UNITED STATES PATENT AND TRADEMARK OFFICE

APPLICATION NO.	FILING DATE	FIRST NAMED INVENTOR	ATTORNEY DOCKET NO.	CONFIRMATION NO.
09/848,701	05/02/2001	Joseph Zelina	H0001340	7935

Office Action Summary

DETAILED ACTION

FIG. 4

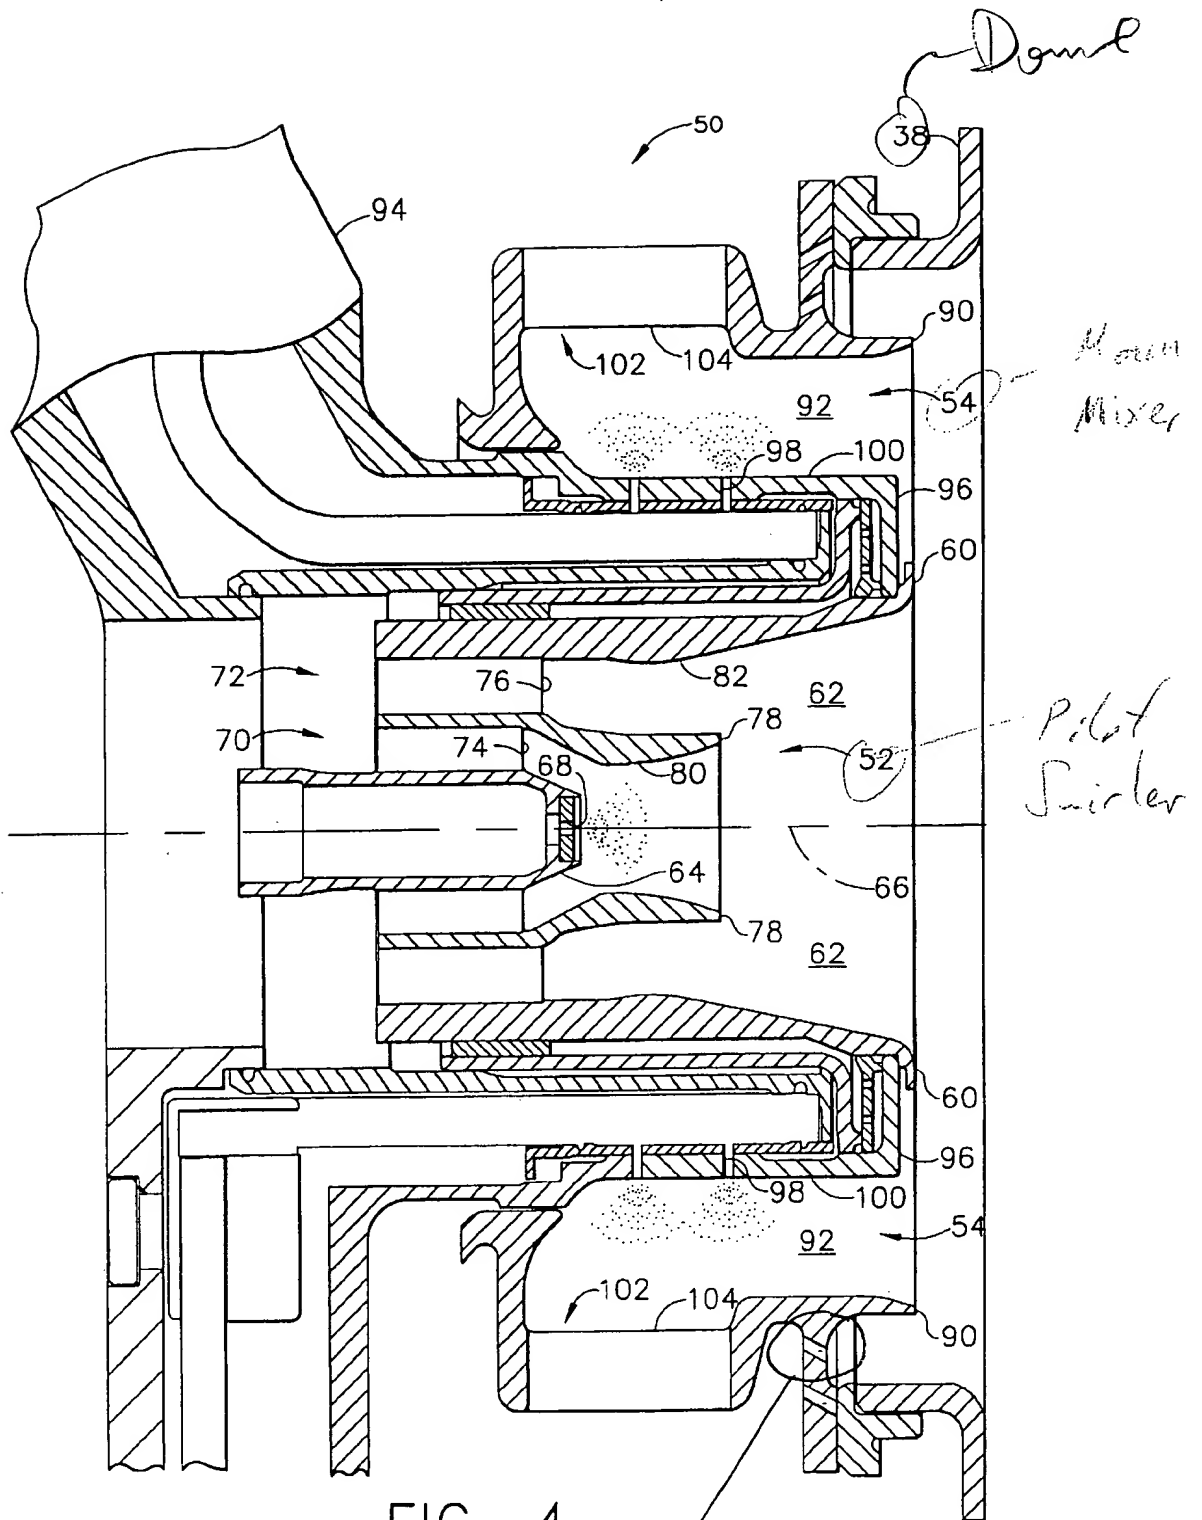
Claims 15 to 21, 23, 24, 34 to 39, 41 and 42, as understood, are rejected under 35 U.S.C. 102(e) as being anticipated by Pritchard et al. Note unidentified dome cooling nozzles shown in figure 4 of Pritchard et al. (Also see attachment “A” which identifies the dome cooling nozzles).
